MEETING OF THE MINTURN PLANNING COMMISSION Minturn, CO 81645 • (970) 827-5645

Wednesday, July 14, 2021 Regular Session – 6:30 PM

Hearing Date:	July 14, 2021
File Name and Process:	Faircloth Garage Addition / Variance Request
Owner/Applicant:	Heather Faircloth
Representative:	Tom Warzecha
Legal Description:	BOOCO Subdivision, Block F, Lot 12 and Part of Lot 13
Address:	261 Main Street
Zoning:	Old Town Mixed-Use (Old Town Character Area)
Staff Member:	Scot Hunn, Planning Director Madison Harris, Planner I
Recommendation:	Approval, with Conditions

Hearing Date:	July 14, 2021
File Name and Process:	Single-Family Residence Final Plan Review
Owner/Applicant:	Emily and Steve Hutton
Representative:	Michael Pukas, MPP Design Shop, Inc.
Legal Description:	Lot 14, Block 2, Booco's 2 nd Addition to Minturn
Address:	482 Eagle River Street
Zoning:	Old Town Character Area – Mixed Use Zone District
Staff Member:	Scot Hunn, Planning Director Madison Harris, Planner I
Recommendation:	Approval, with Conditions

GARAGE LEVEL FLOOR PLAN 1/4" = 1'-0"

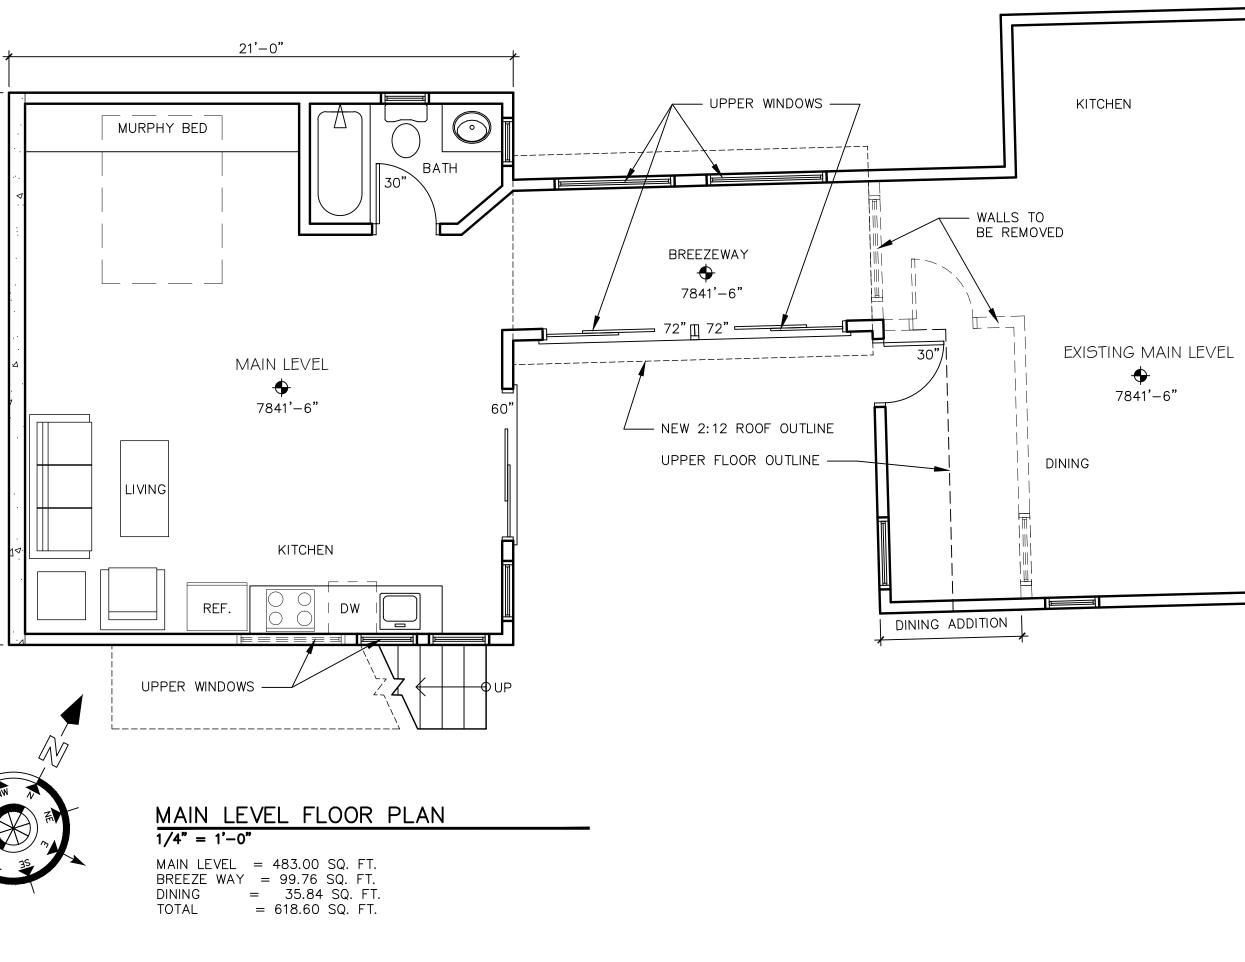
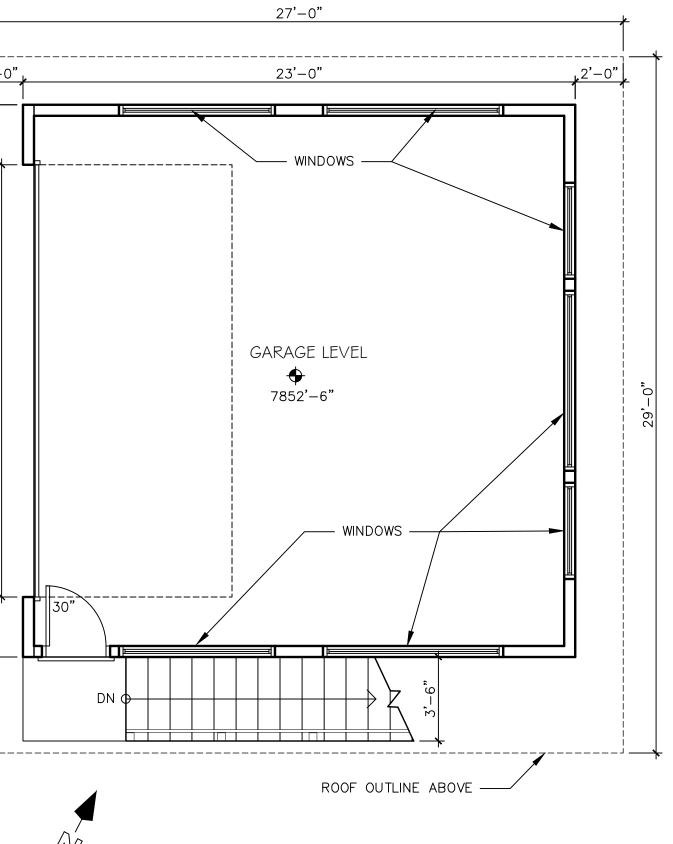
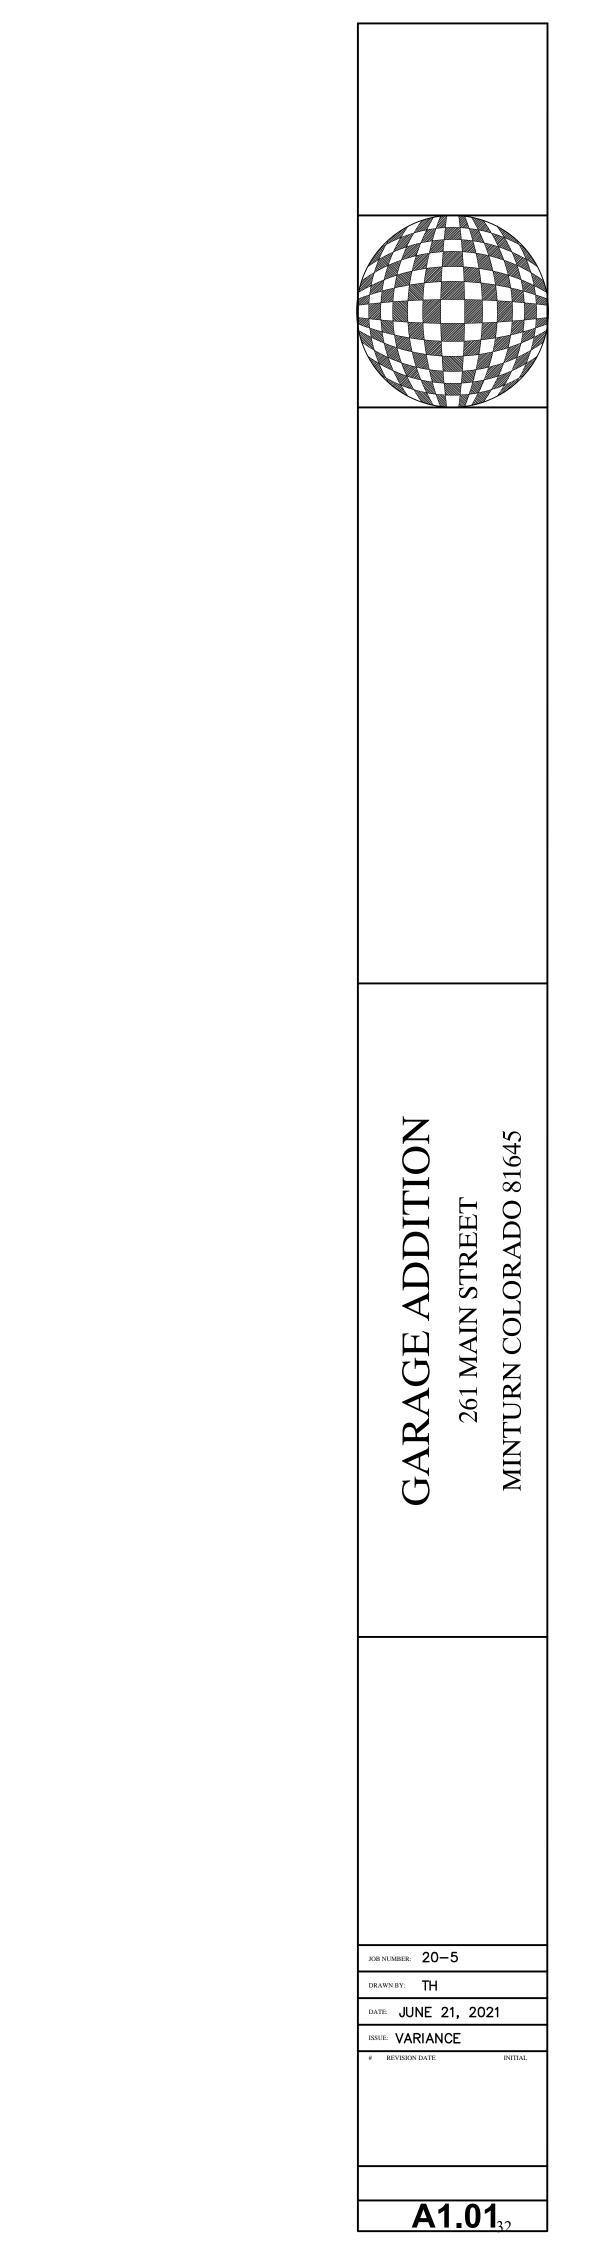
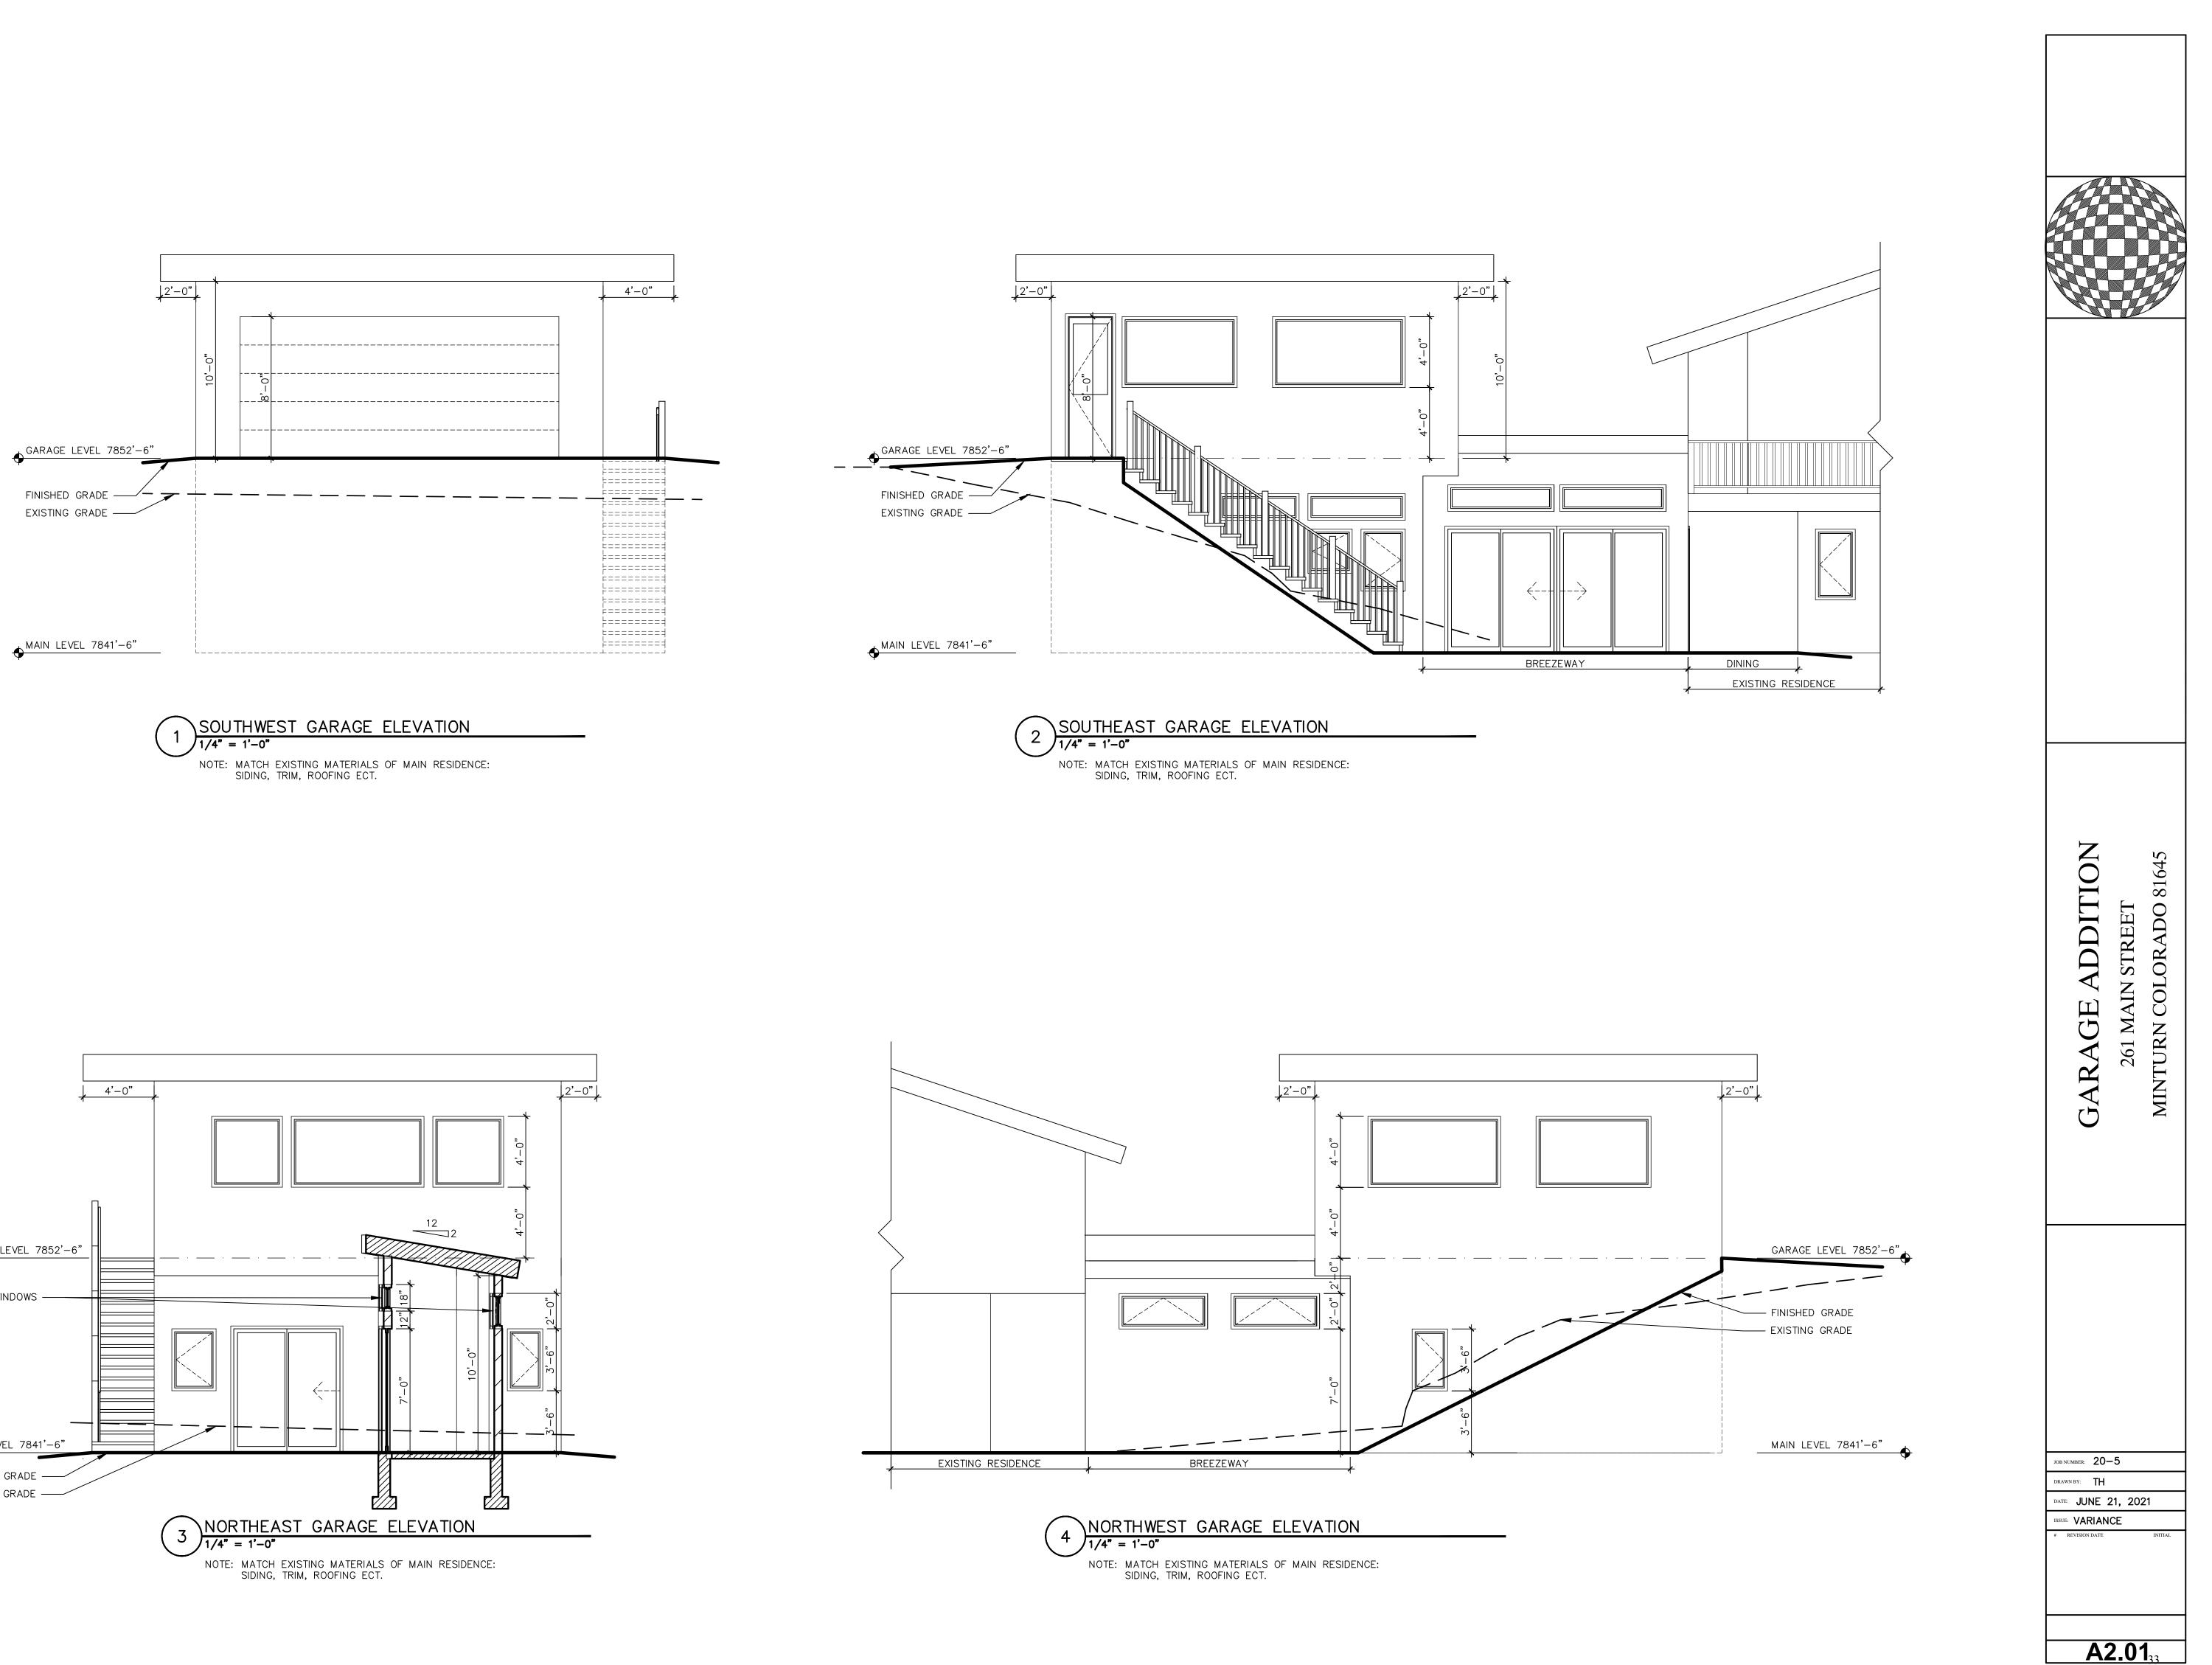
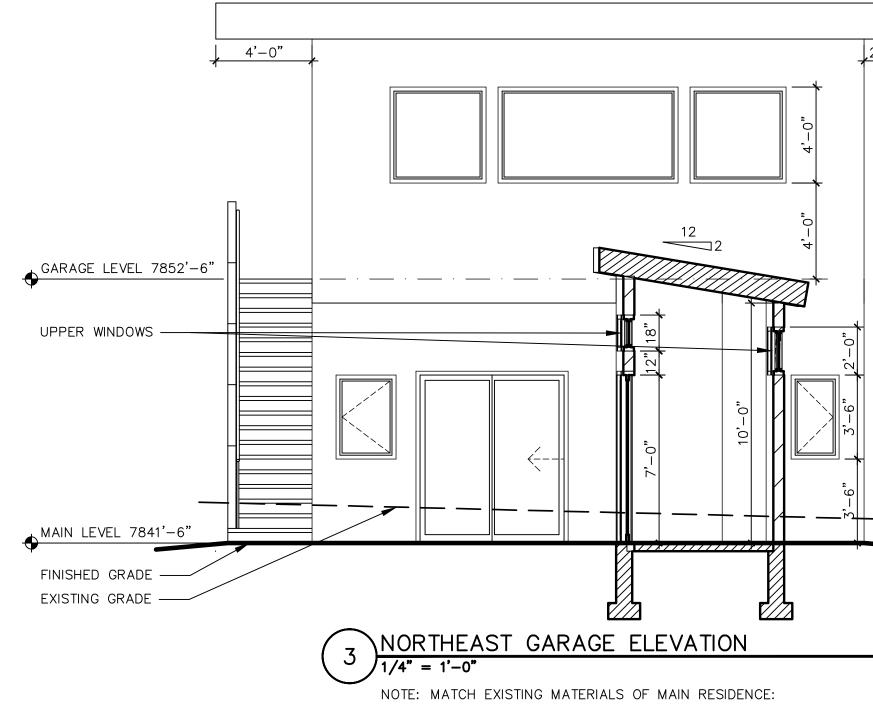
• Exterior Light Fixtures – the floor plans and elevations should be updated prior to building permit to show all exterior lighting locations as well as cut sheet/specifications.

The plans should be updated to show exterior light locations. Light fixtures and lighting solutions are to be dark sky compliant.

- 1. The Applicant shall provide final grading and drainage details, including an updated survey showing spot elevations, for review by the Town Planner and Engineer prior to the submittal for building permit.
- 2. The Applicant shall revise the site and/or floor plans to show all proposed exterior light locations and provide final cut sheets/specifications for proposed exterior light fixtures prior to or concurrent with building permit applications to ensure compliance with the Town's lighting standards as well as consistency with fixtures found on the existing residential structure on the subject property.
- 3. The Applicant shall revise the Final Plans to remove the breezeway and/or revise other aspects of the plan to reduce overall, total impervious surface coverage to no more than 60%.
- 4. The Applicant shall provide final details and dimensions for all proposed exterior
